Valley of the Winds Wind Farm

Amendment Report

Project name **Valley of the Winds Wind Farm**
Project no. **318001172**
Recipient **ACEN Renewables Australia Pty Ltd**
Document type **Amendment Report**
Version **V2**
Date **27/10/2023**
Prepared by **Clare Butterfield / Belinda Sinclair / Jon Williamson**
Checked by **Belinda Sinclair**
Approved by **Belinda Sinclair**
Description **Amendment Report for the Valley of the Winds Wind Farm project.**

Figure 3-5 | Additional substitution in Mount Hope cluster

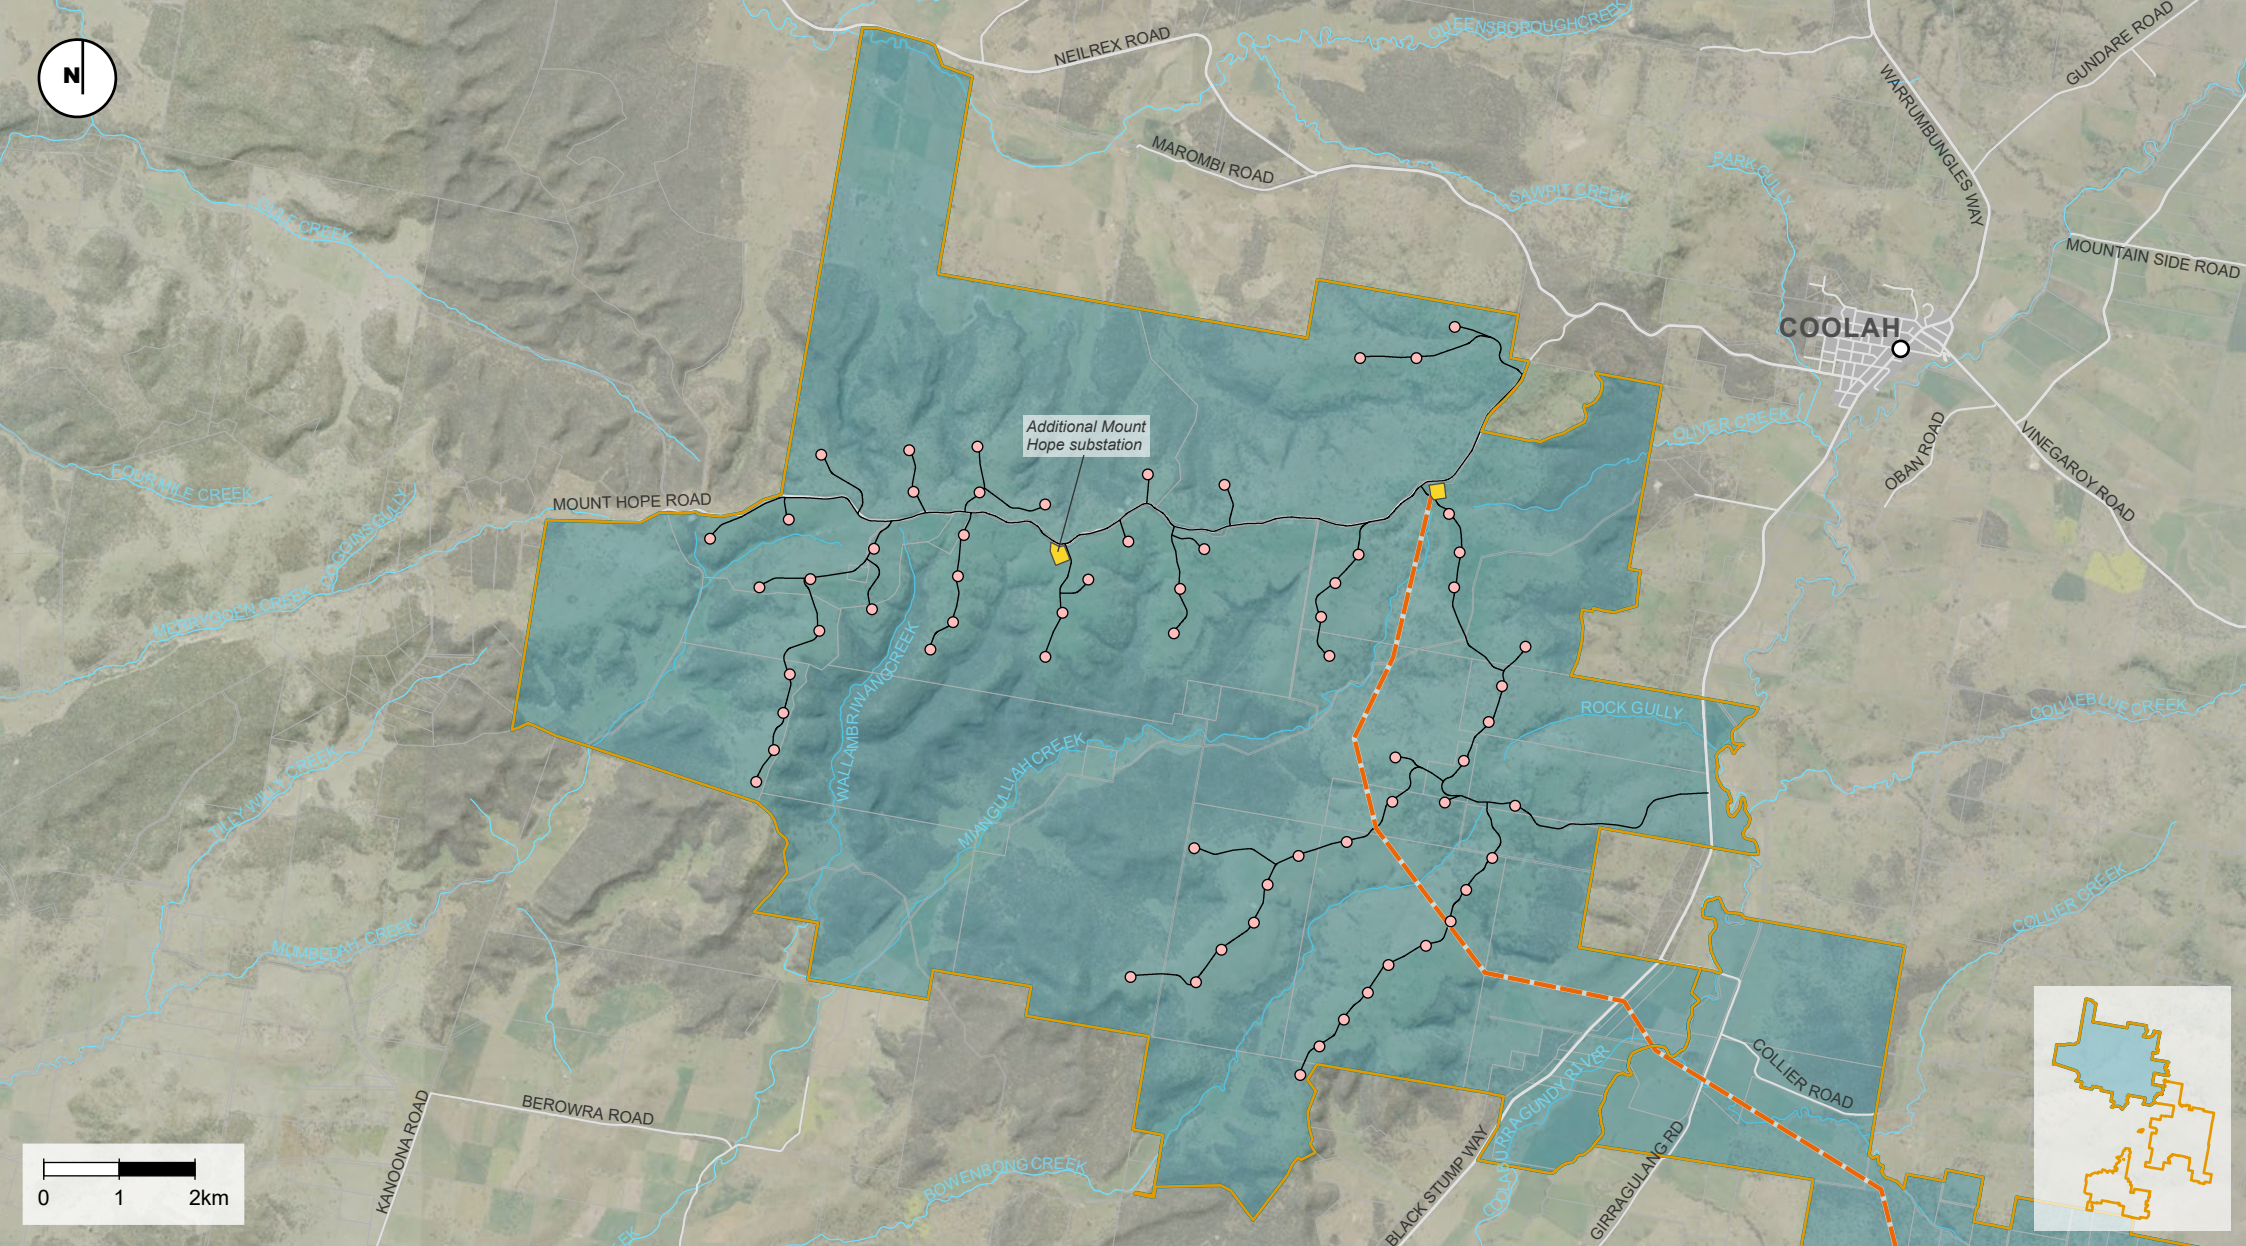
An additional substation has been included following further review of the wind farm layout. The additional substation is required to improve the electrical connectivity of the Mount Hope cluster. The proposed substation would be of similar size and configuration as the existing Mount Hope substation and is expected to require an area of up to 100 metres by 200 metres (two hectares). It would be located close to Mount Hope Road, approximately five kilometres from the existing Mount Hope cluster substation and is shown in **Figure 3-5**.

Figure 3-7 | Amendments to proposed access routes

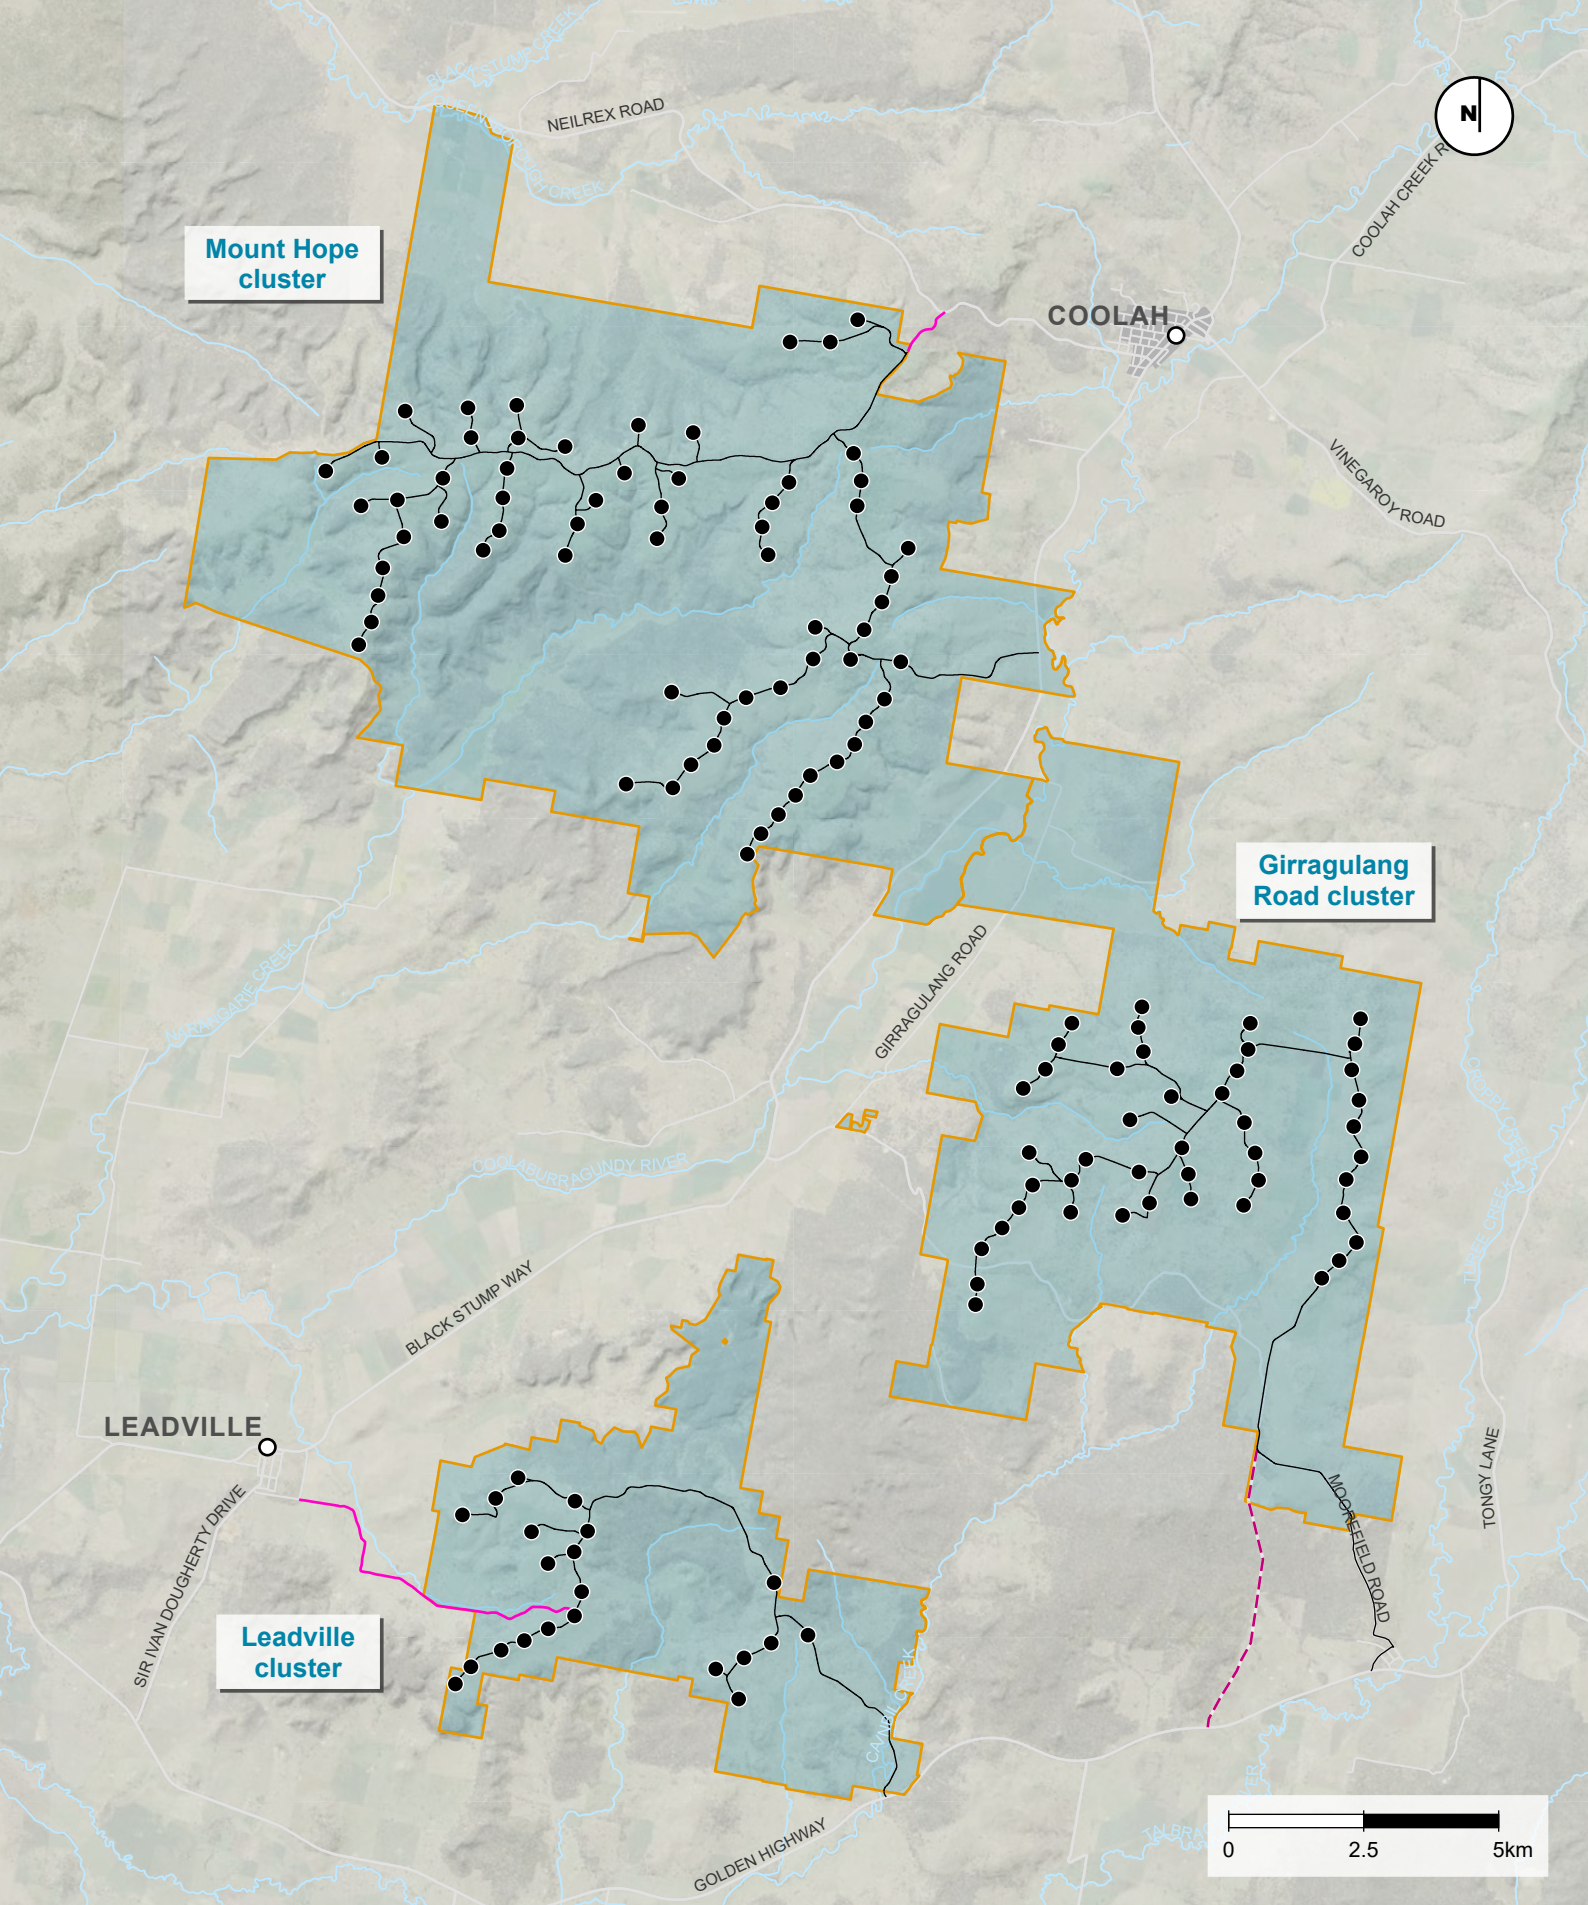
Following consultation since the exhibition of the EIS, ACEN propose to remove two access points as follows:

- removal of the proposed light vehicle access to the Mount Hope cluster via Neilrex Road removed – a single point of access from Black Stump Way is now proposed
- removal of the proposed light vehicle access to the Leadville cluster via the Leadville Stock Route and Wardens Road – a single point of access from the Golden Highway is now proposed.

Removal of the two access points outlined above has reduced the project disturbance footprint by 18.6 hectares, and reduction of potential impacts to biodiversity is discussed in **Section 6.3**.

An additional access option has also been included in response to consultation since the exhibition of the EIS. The proposed access would follow the alignment of the proposed CWO-REZ Transmission Line, from the Golden Highway to the Girragulang Road cluster.

Amendments to access routes are shown in **Figure 3-7**, and updates to the technical assessments as part of this amendment report are discussed in **Chapter 3**.

Figure 3-8 | Amended dwelling status

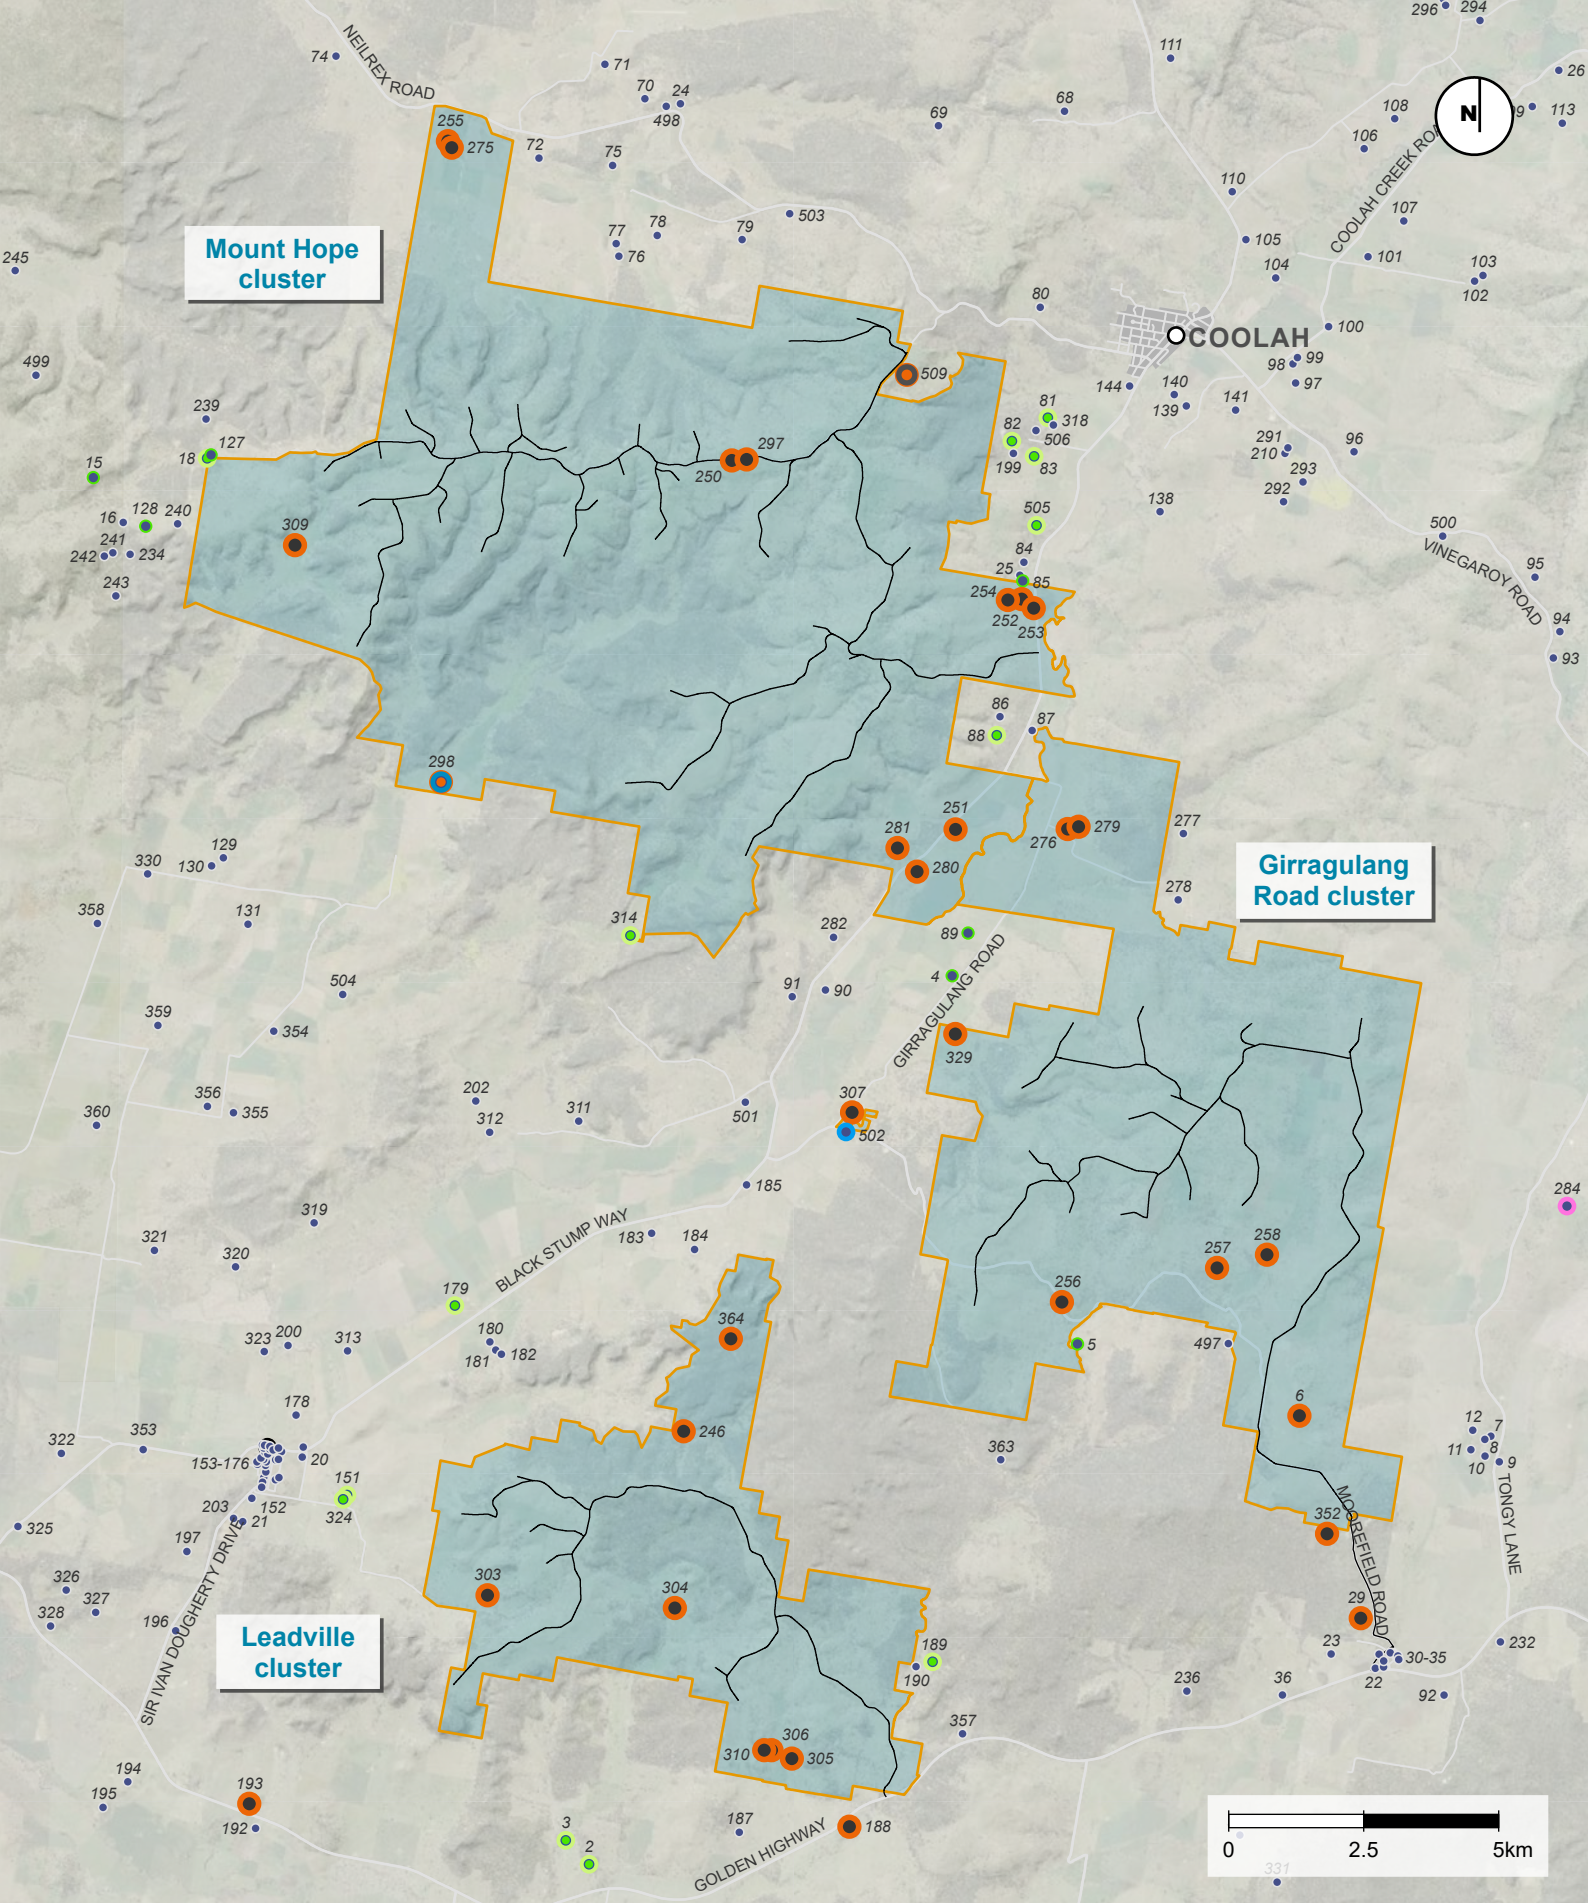
Since exhibition of the original DA, ACEN has progressed agreements with 13 nearby neighbours who are now associated with the project. An additional dwelling has also been added to the assessment of the amended project that was previously burnt down and an additional host dwelling has been identified. All changes to dwelling status are shown in **Figure 3-8** which reflects the status of dwellings at 11 September 2023. Similarly, the technical assessments prepared for the amended project (refer to **Section 3.4**) are based on the status of dwellings at 11 September 2023. As this process will be ongoing, the point in time data reflected in this Amendment Report and associated technical assessments is to ensure consistency in assessment of the amended project.
